Planning Commission Staff Report

Subject: Ordinance Amendment Vote Report

Petition: P.Z. 20-2008 St. Louis Family Church (101 & 139 Valley Center Dr.-17501 Edison Ave.)

RE: P.Z. 20-2008 St. Louis Family Church

PRELIMINARY DEVELOPMENT PLAN

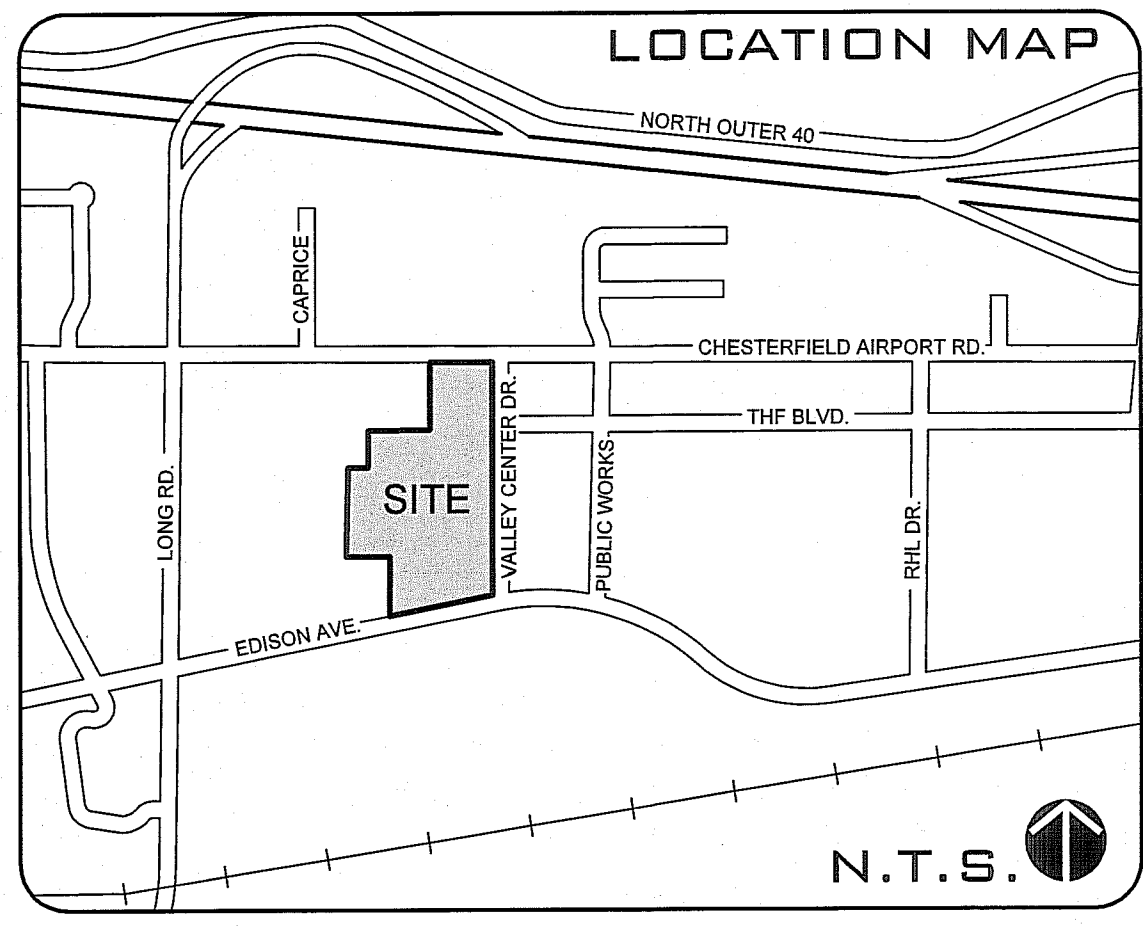
The addition will put the entire building into noncompliance with the 2003 International Building Code. In order to construct a church of nearly 100,000 square feet, it has to meet the requirements for an unlimited area building. One of these requirements is that the building "be surrounded and adjoined by public ways or yards not less than 60 feet in width." The east wall of the proposed building is less than 50 feet from the property line, with the northern 300 feet being only 30 feet from the property line.

In addition the plan does not indicate how tall the building will be. Your Notice of Public Hearing indicates that one of the things that they are seeking to amend is building height requirements. If it's over 30 feet tall, none of the drive aisles around the building will be in compliance.

Petitioner's Response: Petitioner acknowledges these comments and will work with Monarch Fire Protection District to satisfy all requirements for this project.
